TOP HOODLUM PROGRAM
CHICAGO DIVISION
CG 6486-C*

Referenced letter requested advice of the FBI Laboratory concerning use of a simplex circuit to enable operation of two MITES on a selective basis over the same telephone line.

SYSTEM FOR SELECTIVE OPERATION OF EITHER OF TWO MITES OR MATES

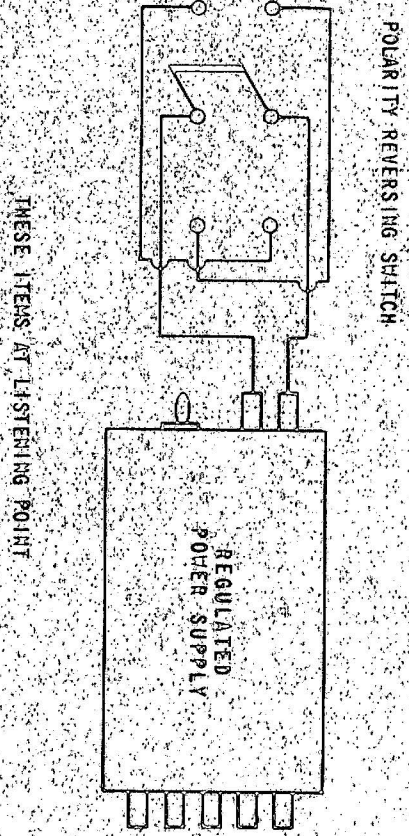
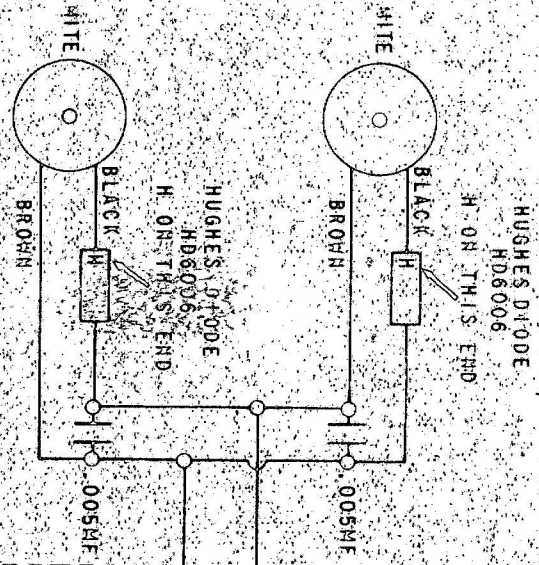
Switching of two MITES on one line can be more easily accomplished by the use of diodes which are smaller than the polar relay and much more easily concealed. There is attached a diagram showing method of using diodes. It is recommended that this circuit be utilized in preference to the simplex circuit as it is simpler to install and will not introduce noise into the microphone line.

THESE ITEMS SHOULD BE INSTALLED AT
POINT TO BE MONITORED.

DIODES AND CAPACITORS SHOULD BE AS
CLOSE TO MITE AS POSSIBLE.
